McClellan Air Force Base

US Air Force Proposes Plan for Interim Remedial Action for PCB Contaminated Soils

June 1993

The following are EPA's comments on the McClellan Air Force Base Proposed Plan for Operable Unit B1:

Figure 2 - McClellan AFB Operable Units

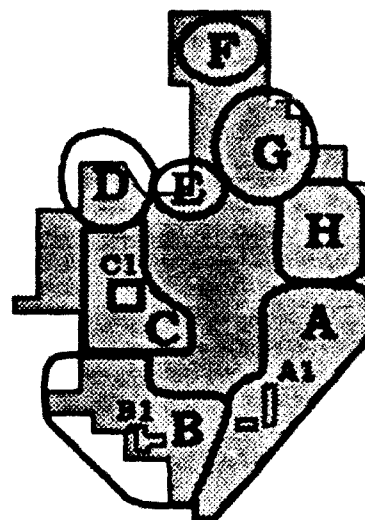
3. Page 3, section 3.1.2 - OUB1. Please include text as to the number of operable units, the chemical contaminants, and expected timeframe for investigation and cleanup. Since this is the first operable unit, a definition should be included as part of this text.

Reference to the other operable units as well as a map showing their locations has been added to the Proposed Plan.

Figure 4. Comparative Analysis of Remedial Alternatives

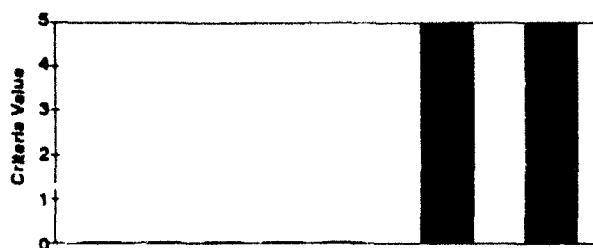
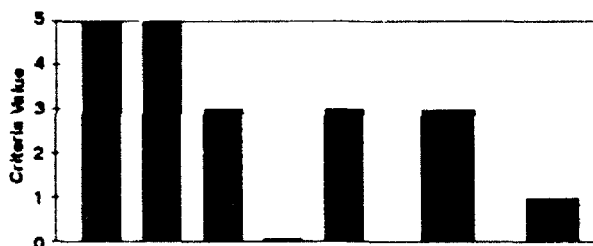
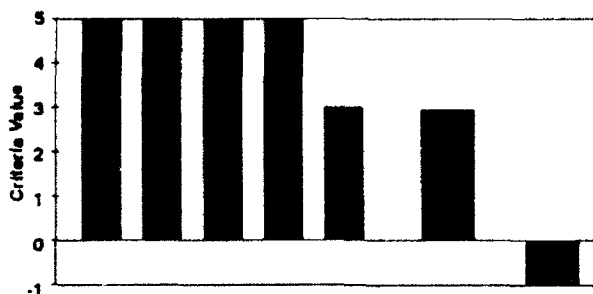
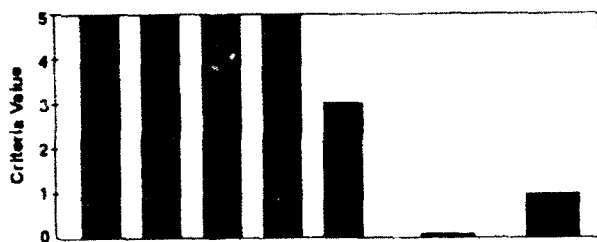
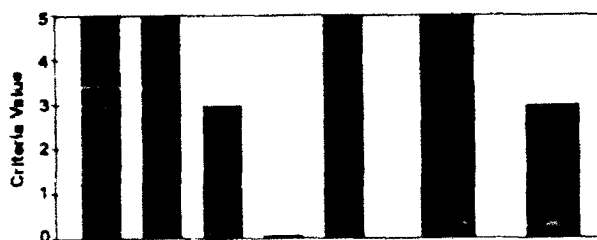
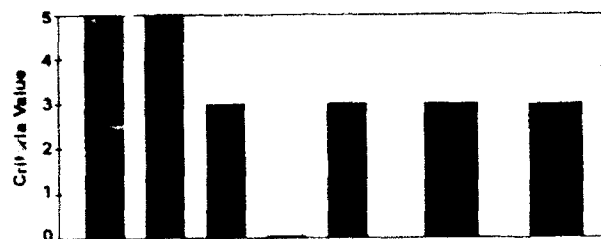
9. Page 10, Section 6.2. Please provide the criteria/numerical value spreadsheet as part of the Proposed Plan.
10. Page 10, Section 6.3. It is the Department's understanding that the entire DRMO lot would be capped and that the capping action would cover all known PCB contamination (not just "contamination at and above 10 ppm.") PCB contamination outside the DRMO area would be excavated and consolidated with the DRMO soils prior to capping.

The criteria/numerical spreadsheet has been added to the Proposed Plan.
